MECKLENBURG COUNTY HEALTH DEPARTMENT

APPLICATION FOR PERCOLATION TEST

SITE DISAPPROVAL REPORT
INDIVIDUAL SEPTIC TANK SYSTEM WITH SUBSURFACE,
SOIL ABSORPTION, EFFLUENT DISCHARGE

LOCATION OF LOT Mountainview Drive, Lot 26

7) ACCURATELY DIAGRAM & DIMENSION LOT

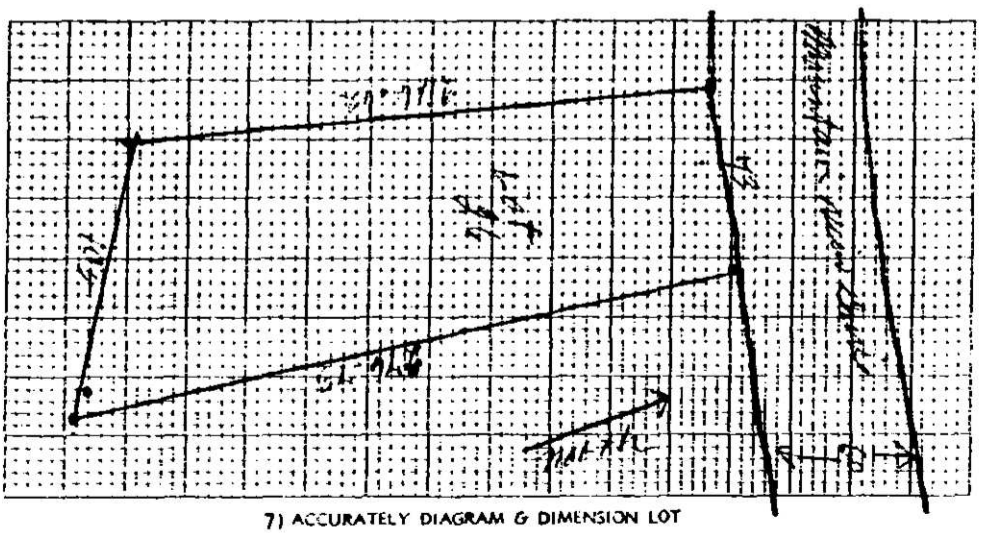
X ON SITE INSPECTION REVEALED LOT TO BE UNSUITABLE FOR THE FOLLOWING REASON(S) 2-25-74 Soils were found to be a shallow phase of the Pacolet series. These soils are extremely shallow to rock material. The depth to rock varies from 5 to about 4 feet. These soil characteristics impose extreme physical limitations on the installation of sy[illegible] potential for lateral seepage of effluent resulting in the wastes coming to the soil surface.
